Blumel Hall

Re-pipe & Remodel

PORTLAND STATE UNIVERSITY

Revisions :	Date :
1 5 / 4 / 12 ADDENDUM #1	4/17/12

A7.1

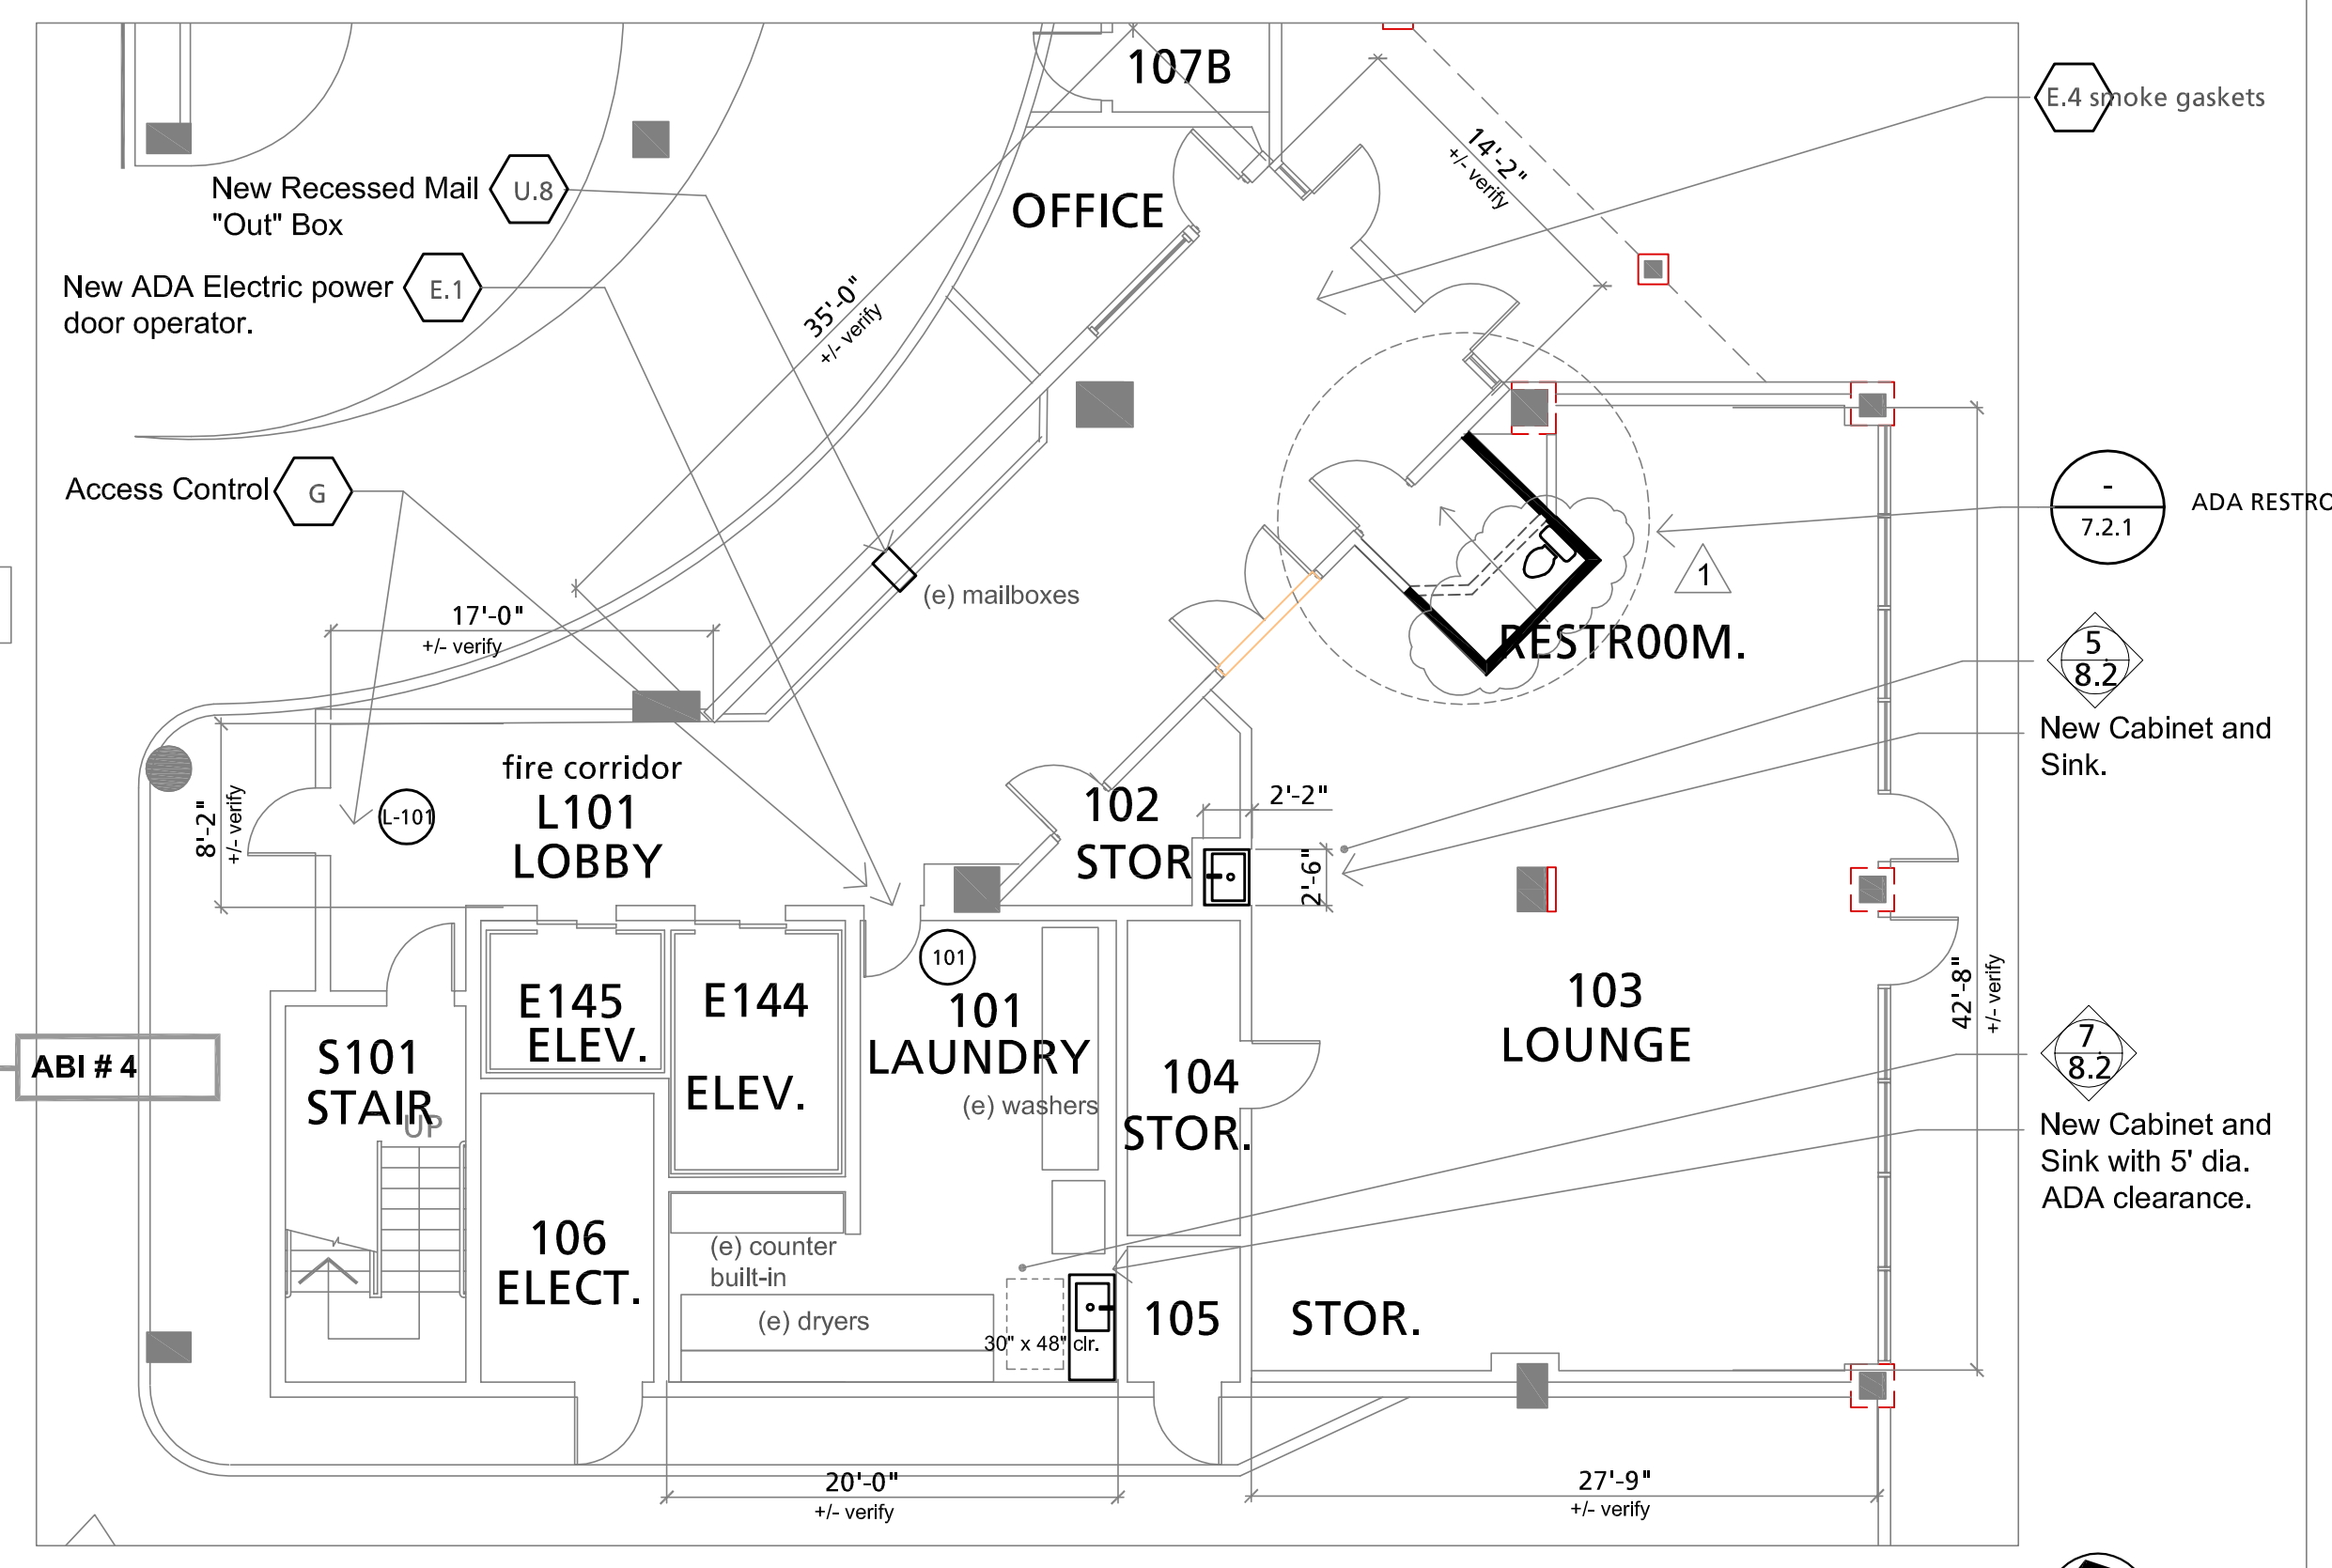
1. See specification sheet for notes.
2. Prior to paint stripping removal, inventory parking stall layout and total spaces. Replicate layout and number of spaces, with the exception of the accessible parking and minimum drive aisle areas.
